City of Richmond
Urban Development Division

**Report to
Development Permit Panel**

To: Development Permit Panel
From: Joe Erceg
Manager, Development Applications
Date: July 7, 2003
File: DP 03-234836
Re: **Application by Northwest Development Ltd. for a Development Permit at
11311/11331 Cambie Road**

SITE PLAN

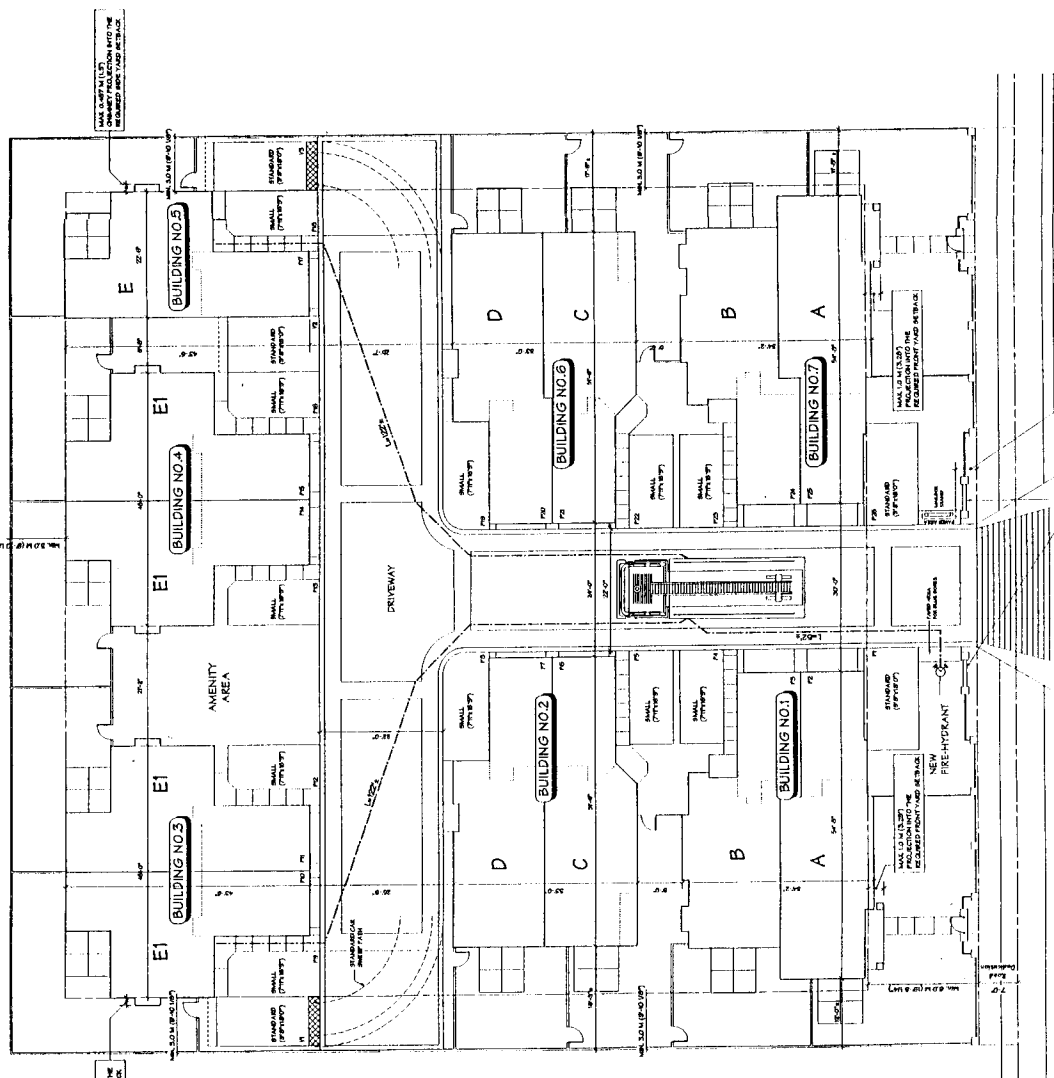
1. Eliminate the amenity area along Cambie Road and enlarge the amenity space between buildings 3 and 4. ***The amenity area along Cambie Road has been eliminated and the amenity space between buildings 3 and 4 are enlarged by relocating a visitor's parking space.***

2. The pavement width of all internal drive aisles should be at least 6.706 m (22 ft) wide excluding curb and gutter. This width of drive aisle is deemed necessary to accommodate vehicle manoeuvring since this internal roadway system will form part of an informal lane way parallel to Cambie Road. *Driveway is widened to 22 ft. including curb and gutter. If curb and gutter is added to the 22 ft. driveway, all landscaped areas in front of garages will have to be eliminated. The applicant cannot reduce the building depth any further.*

3. A dimensioned site plan is requested. Demonstrate with turning radii that there is adequate vehicle manoeuvring space at critical locations such as the 'T' intersection and egress from visitor parking stalls V1 and V3. *Dimensions are added onto the site plan. The widened driveways improve the vehicle manoeuvring spaces at the 'T' intersection and parking access.*

4. Parking stalls V1 and V3 are non-functional and must be revised. *Driveway is widened and additional manoeuvring space has been provided for parking stalls V1 and V3.*

5. The southern-most parking stall (opposite the mailbox) is too close to Cambie Road and must be relocated or eliminated. *The southernmost parking stall is relocated to the opposite side of driveway away from Cambie Road.*

2. The two parking stalls at the front entry should be relocated; ***The two parking stalls at the front entry have been reconfigured with one parking stall on each side of the driveway and additional landscape screening has been provided.***
